QA/QC Comments Response Letter

WVUSD Comments Response Letter, WVUSD Pasqual Gutierrez
August 2, 2024

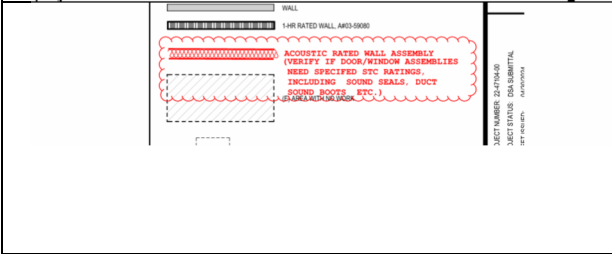
SCOPE OF WORK.
 4. CONTRACTOR IS TO REFER TO **EQUIPMENT / FURNISHINGS PLAN** FOR ADDITIONAL INFORMATION ON ALL EQUIPMENT AND FURNISHINGS.
 5. GENERAL NOTES APPLY TO ALL REMODEL SHEETS.
 6. REPAIR ALL WALL SURFACES / MATERIALS WHERE FINISHES WERE REMOVED OR DAMAGED DURING RENOVATION WORK.

NO SUCH PLAN IN DRAWG. SET?

Note #4 removed from sheet general notes. Refer to general notes on A2.21

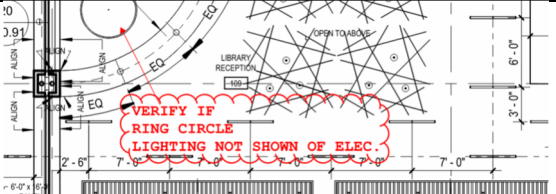
FOR CONNECTION DETAIL, UNLESS DETAILED OTHERWISE.
 19. REFER TO 6/A3.11 FOR FIRE RATINGS & DETAIL REFERENCES FOR FIRE RATINGS.

Reference to sheet A2.21 added to note #19, refer to sheet general notes on A2.21

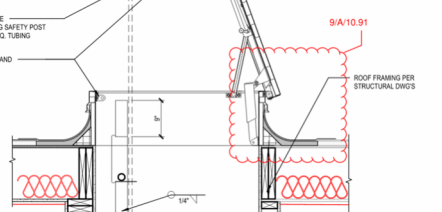
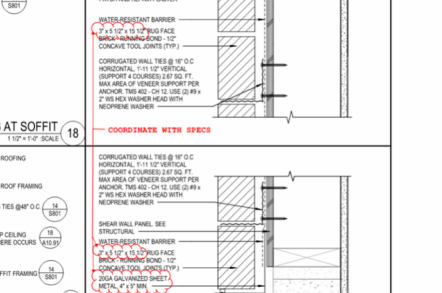
<p>OPERABLE PARTITION WALL</p> <p>OPEN</p>	<p>Operable wall has been coordinated with Kwikwall vendor, interior elevation updated, refer to 16/A8.13</p>

<p>STUDIO ROOM A.117 - SOUTH</p> <p>COORDINATE LOCATION OF FA STROBE</p>	<p>Location of FA horn and strobe coordinated, height AFF indicated per FA drawings. Refer to 15 & 11/A8.12 and 4/FA4.01</p>																		
<p>OPERABLE PARTITION WALL</p> <p>OPEN</p>	<p>Operable wall has been coordinated with Kwikwall vendor, interior elevation updated, refer to 10/A8.13</p>																		
<p>YARD PAINTED</p> <p>NT BASE</p> <p>ED WINDOW GRAPHIC 10" BY OLDCASTLE MATERIALS</p> <p>CONSIDER RE-SPECIFYING FOR COMMON GLASS RESOURCE</p> <p>APP: 03-1238 REVIEW SS <input checked="" type="checkbox"/> FLS DATE: 05/</p>	<p>Updated to indicate Vitro Architectural Glass, refer to keynotes on A8.14</p>																		
<p>A8.15</p>																			
<p>OFCI REFRIGERATOR COORDINATE WITH PLUMBING FOR 1/4" COPPER WATER LINE</p>	<p>OFCI refrigerator added and coordinated with plumbing. Refer to 7/A2.21, 2/A8.15, 1/P2.21</p>																		
<p>A9.11</p>																			
<p>EXISTING</p> <p>EXISTING</p> <p>VERIFY/COORDINATE WITH DEMO DRAGS. DOOR INDICATED AS REMOVED?</p>	<p>Existing frame to remain, refer to keynote 02.207 on A2.01 and revised comment on Door Schedule on A9.11</p>																		
<p>VERIFY IF DOOR UNDERCUT IS NEEDED DUE TO ROOM HVAC AIR SUPPLY WITH NO RETURN</p>
